## PRODUCT SERVICE BULLETIN

Bulletin Number: FB 2021-01

SUBJECT: Firebird V1R1 EVO Harness container systems with adjustable Main Lift Web

STATUS: MANDATORY INSPECTION BEFORE NEXT JUMP

## PICTURES

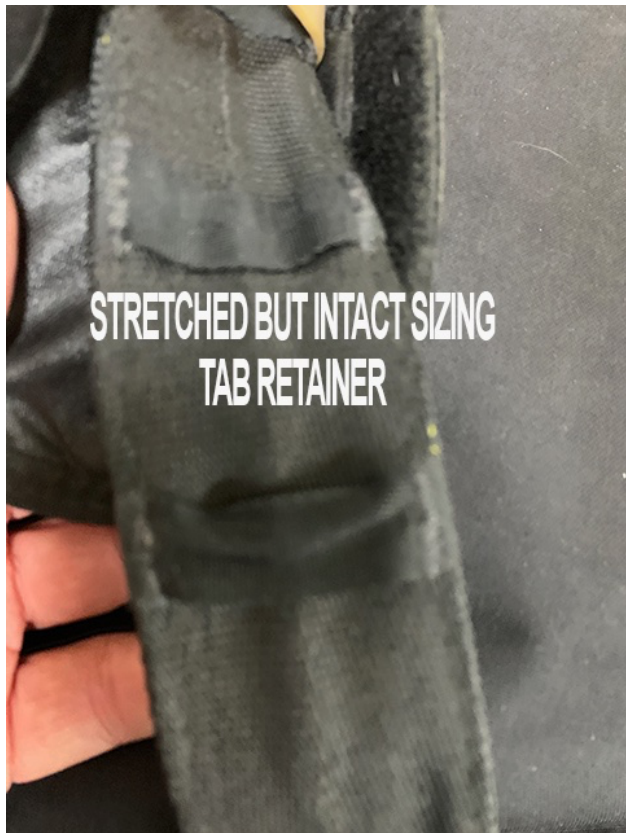
**Right** Main lift web undone, sizing safety tab ripped off and stuck under a stretched but intact sizing tab retainer (1/2" type 1), 555-2 ring installed **correctly**, **missing** spring, **NO** damage to type 4 stopper.

**Left** Main lift web threaded **incorrectly** (double routing, wrong direction, see pics), sizing safety tab attached with only a few stitches (69tex/E thread) ripped, sizing tab retainer stretched but intact, 552-2 ring installed **correctly**, spring present, **NO** damage to type 4 stopper.

The incorrectly routed webbing on the **left** side strongly indicates that, the **right** side that came undone, most likely also had been routed incorrectly.

In this incident, it appears that, the only thing that kept the webbing from coming undone, was the engaged sizing safety tab in the type 1 sizing tab retainer and that it subsequently broke under the load of the opening as **zero** damage to any other component occurred.

Therefore, we mandate a visually inspection before the next jump, to confirm the correct routing of the adjustable main lift web through a type 555-2 ring (DJA/CWH) especially if the container has been disassembled for repairs, maintenance, cleaning, or any other reason. All direct customers have been contacted by Firebird USA LLC.
